**PROJECT: Town of Ridgeland Water and Sewer Resiliency Improvements
TOR-2023-02**

ADDENDUM: Two (2)

Town of Ridgeland Water and Sewer Resiliency Improvements (TOR 2023-02)

DRAWING NUMBER
E10.1

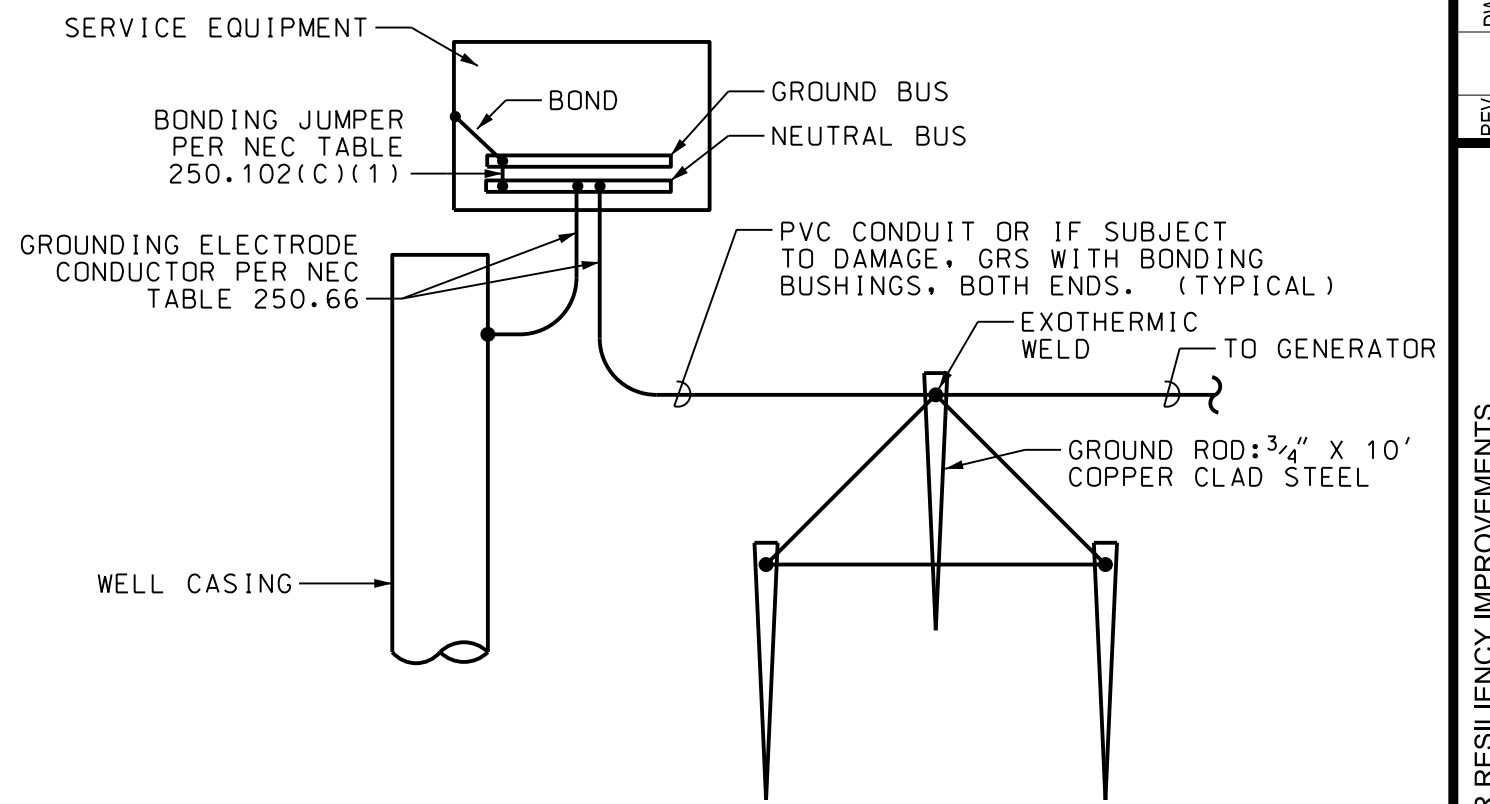
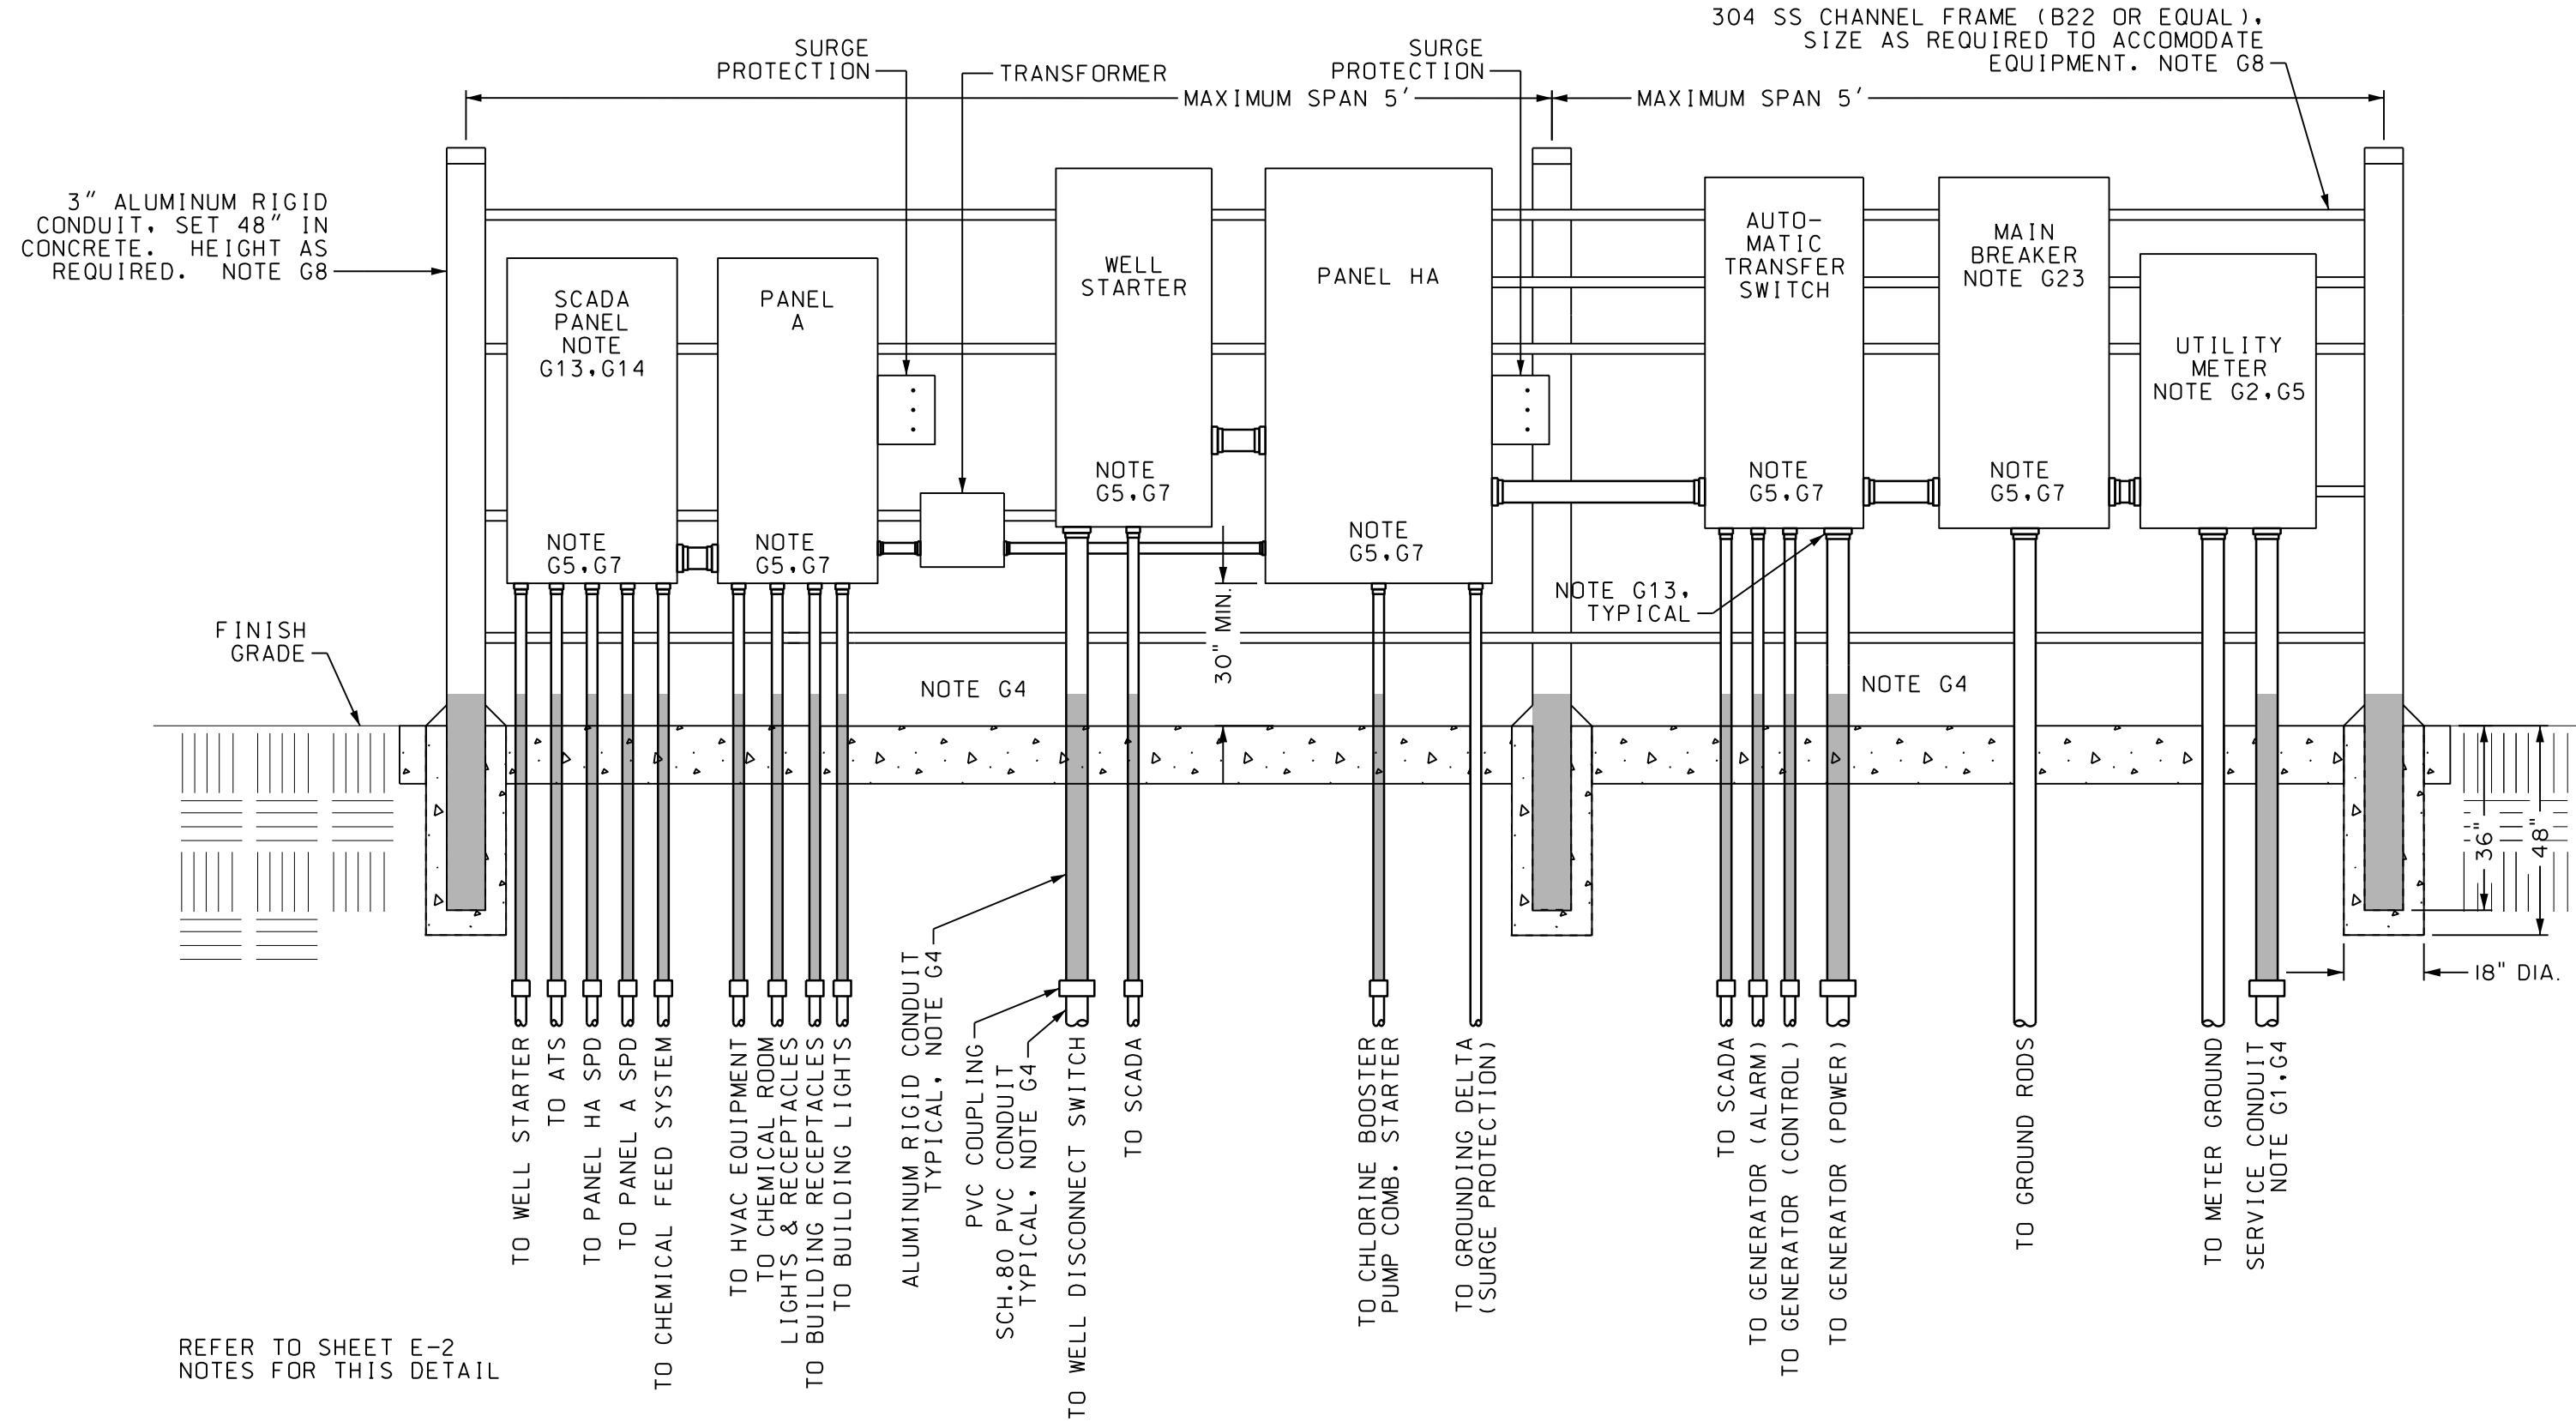
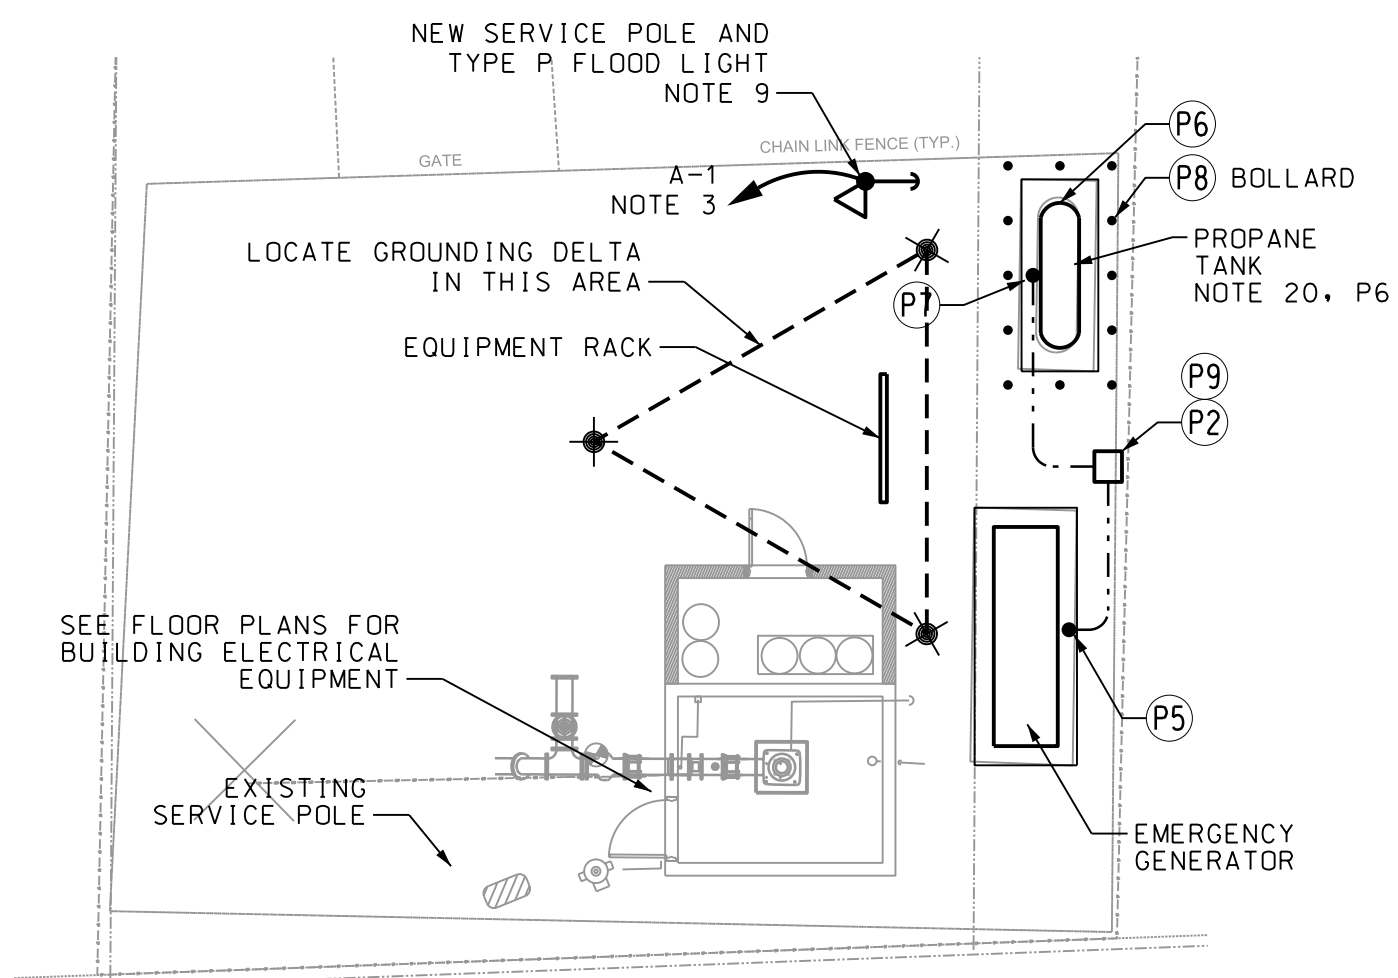
- a. Part III: Well Site 2 Improvements
 - i. E10.1 and E10.2: Electrical improvements updates to address chemical treatment system modifications.
